Docket Item # 6  
BAR CASE #2012-0036

BAR Meeting  
March 7, 2012

**ISSUE:** Certificate of Appropriateness

**LOCATION:** 601 King Street

**Figure 11: Proposal for North Saint Asaph façade includes an awning, 2 exterior light fixtures, and a small brass plaque that identifies the building.**

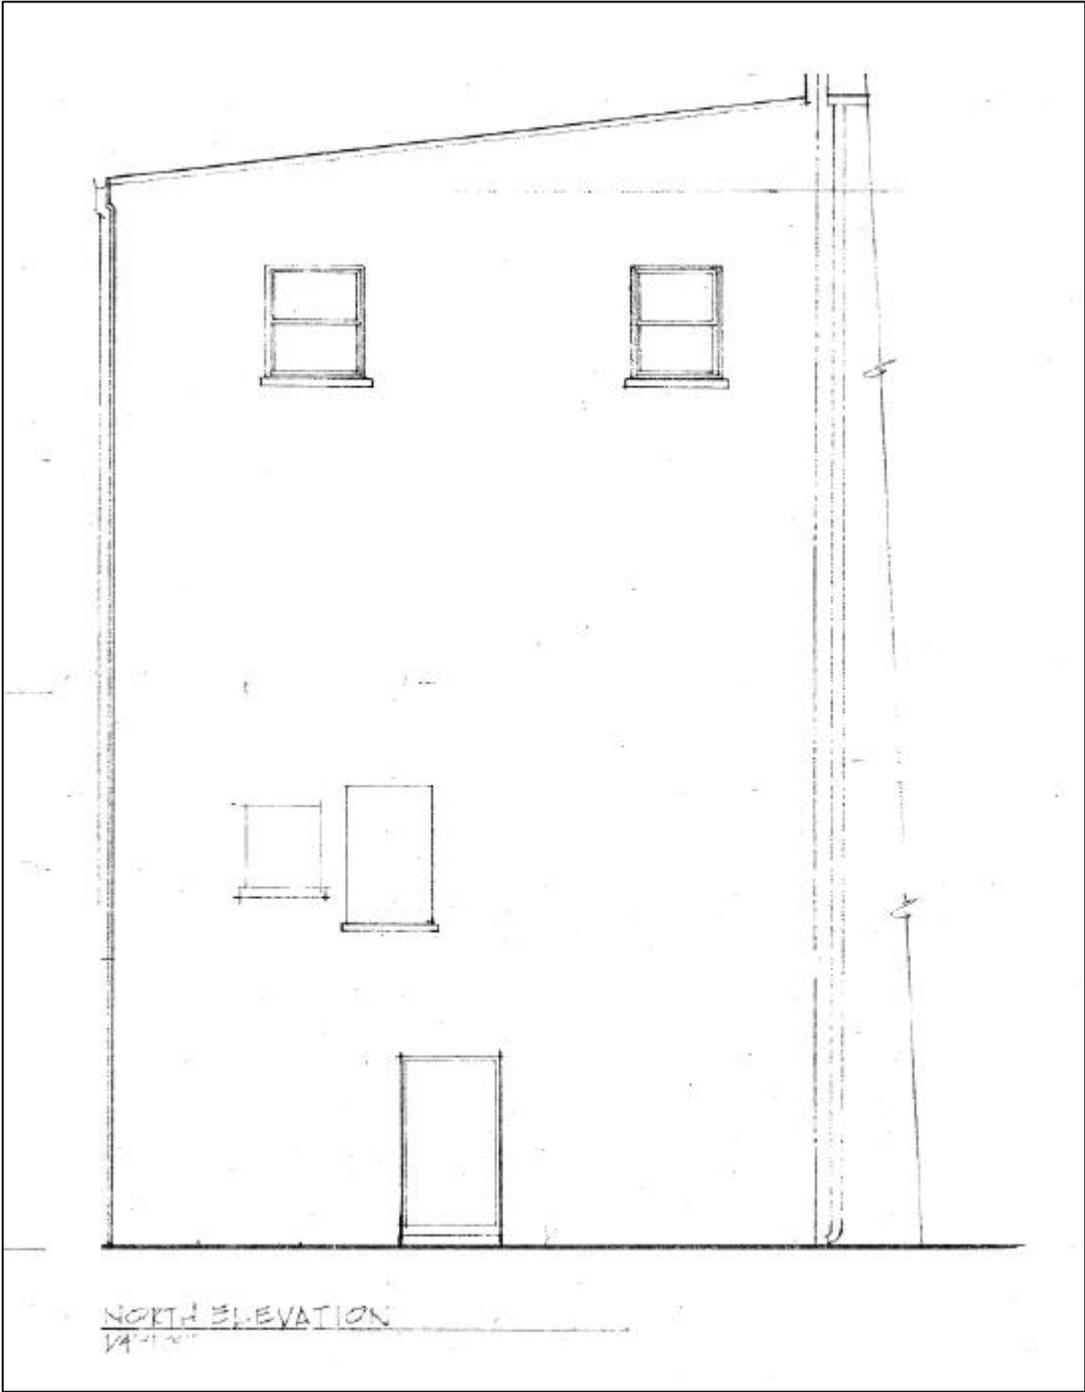
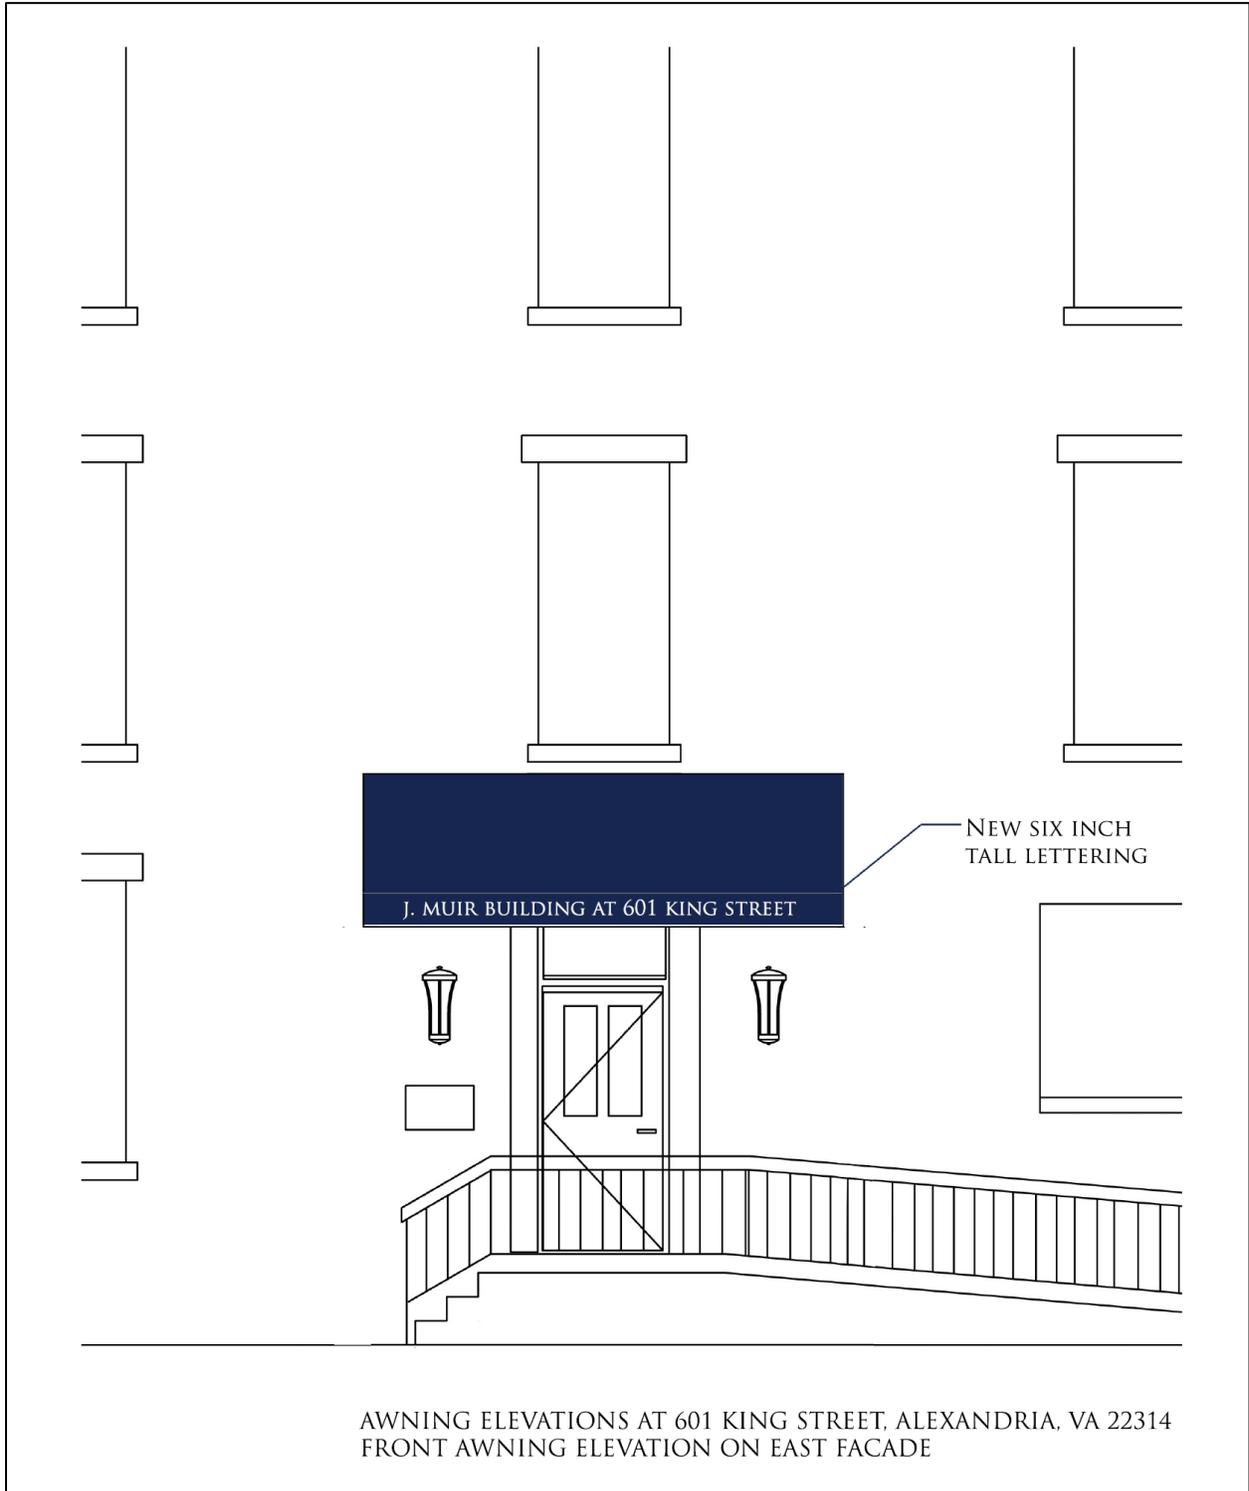
The *Design Guidelines* state that “awnings should be appropriate and sympathetic to the historic style of the building to which they are attached” and “should not overwhelm or obscure the architecture.” The previous awning was installed inside the door trim. The new awning will be installed on the outside of the door surround and will extend out further than the previous one. It measures 11.75” long by 45” wide by 45” high. It will be covered in navy Sunbrella brand fabric and will have text on it to identify the building (see signage section). While the awning is much larger than the entrance, it is in scale with the handicap ramp directly below it and the overall scale of the North Saint Asaph Street facade. Staff notes that the installation of the top of the awning should remain between the door surround and the sill on the second floor window. The awning anchors should also be installed in the mortar joints, not the brick.

Staff checked with the Fire Marshall to insure that there are no concerns with labeling the North Saint Asaph entrance with a King Street address. In order to avoid confusion for first responders, the Fire Marshall has requested that a sign be installed adjacent to the KNOX (building master key) Box identifying the location of the Fire Department hose connection (FDC).
